HOWARD COUNTY HISTORIC PRESERVATION COMMISSION
ELlicott City Historic District ■ LAWYERS HILL Historic District
3430 Court House Drive ■ Ellicott City, Maryland 21043

Agenda

Thursday, January 14, 2021; 7:00 p.m.

HPC-20-83 – 8049, 8055, 8059, 8061 (Tiber Park) and 8069 Main Street; Vicinity of Maryland Avenue and Main Street; Vicinity of 3711 Maryland Avenue along Patapsco River, Ellicott City – continued from December 3, 2020

Figure 13 - Proposed terraced floodplain/culvert/expanded stream channel.

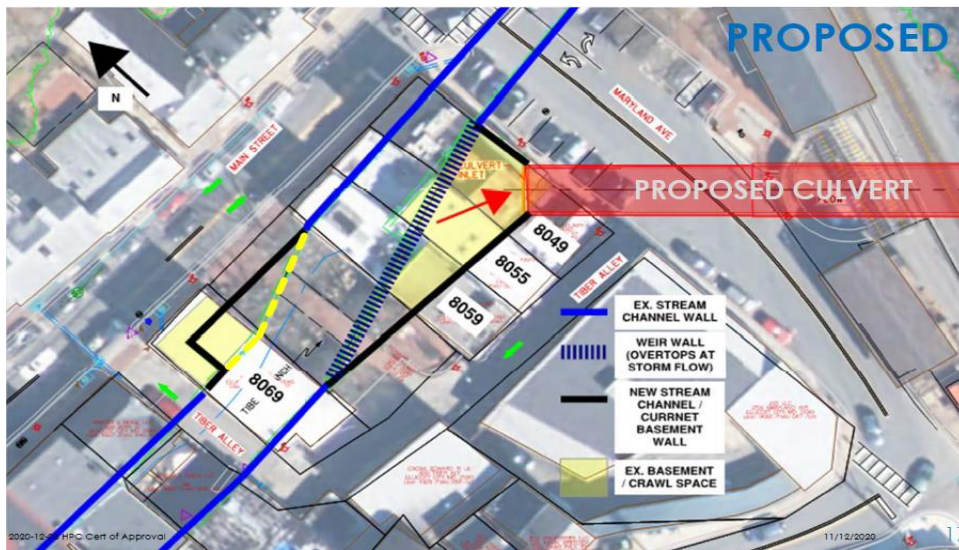
- 6) For HPC-20-83f, the construction of expanded terraced floodplain/culvert and associated components:
 - a. Staff recommends the Commission determine if there is sufficient detail to approve at this time, and whether or not the application complies with the Guidelines and §16.607 approve, deny or continue accordingly. Staff recommends that the Commission determine whether the proposed demolition and new construction comply with the Guidelines and §16.607 and §16.608 of the County Code.
